Work Order ID 108696

Item Name: Crosstube Turning Detail

DART AEROSPACE LTD	Work Order:	108696
Description: Crosstube Assembly (205/212/412 High Fwd)	Part Number:	D212-664-141
Inspection Dwg: D212-664-141 Rev: D		Page 1 of 2

DRAWING NO. D212-664-141	TITLE XTUBE ASSY (205/212/412 HI FWD)	REV. D	DART AEROSPACE LTD ENGINEERING ORDER		D.E.O. NO. D212-664-141-D-1	SHEET NO. SHEET 1 OF 2	SCALE NTS
DRAWN	CHECKED	MP	MFG. APPR.	APPROVED	DE APPR.		
DATE 11.04.07	DATE 11.04.11		DATE 11.04.12	DATE 11/04/12	DATE 11.04.12

**D212-664-141/-141B
ASSEMBLY DETAIL**

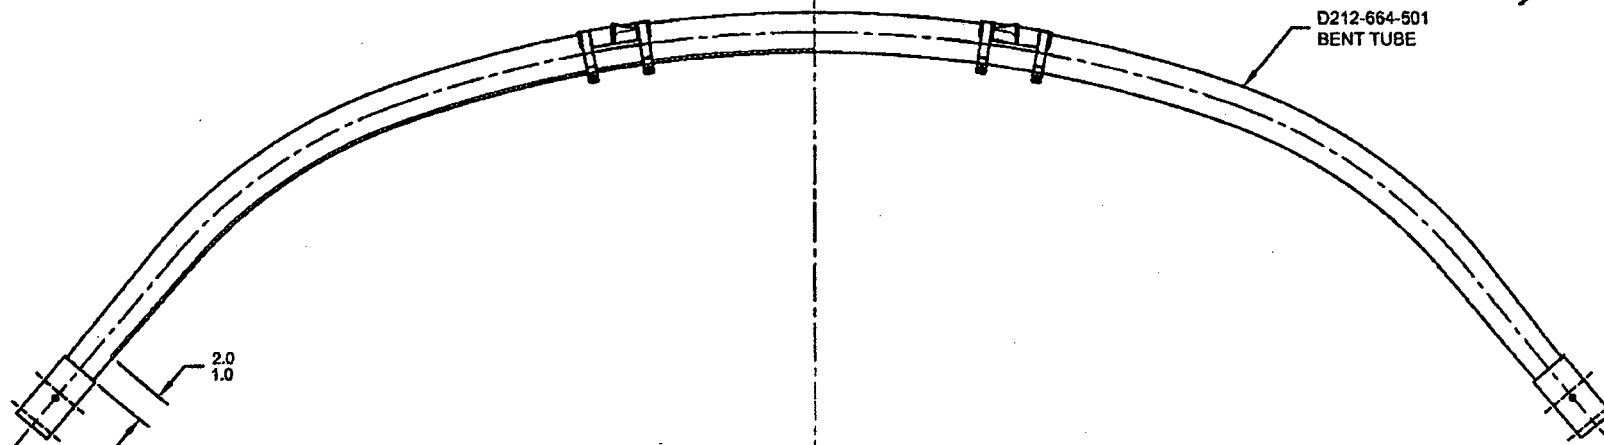
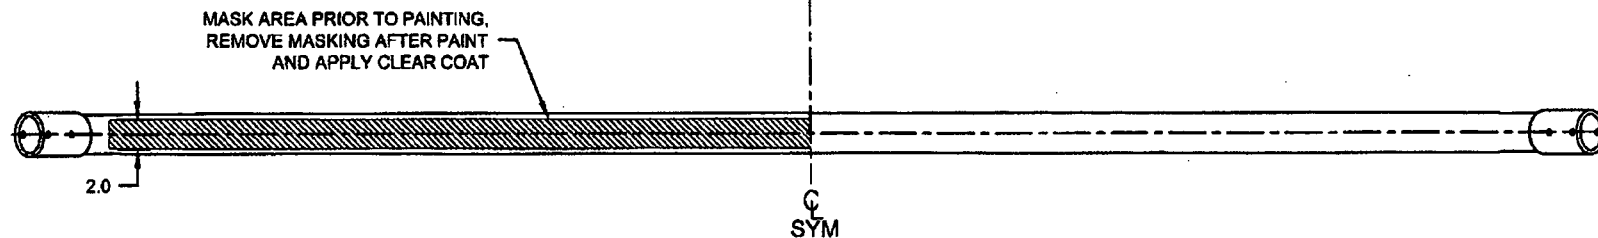
PURPOSE:

ADD AN INSPECTION WINDOW TO UNDERSIDE OF CROSSTUBE.

CHANGE:

NOTES 2 OF SHEET 1 IS AMENDED AS FOLLOWS:

IS:

- 2) FINISH: CHEMICAL CONVERSION COAT PER DART QSI 005 4.1
PRIME INSIDE AND OUTSIDE PER DART QSI 005 4.2
MASK UNDERSIDE OF CROSSTUBE AS SHOWN (HATCHED AREA) AND
PAINT OUTSIDE PER DART QSI 005 4.2
REMOVE MASKING AND APPLY CLEAR COAT

WAS:

- 2) FINISH: CHEMICAL CONVERSION COAT PER DART QSI 005 4.1
PRIME INSIDE AND OUTSIDE PER DART QSI 005 4.2
PAINT OUTSIDE PER DART QSI 005 4.2
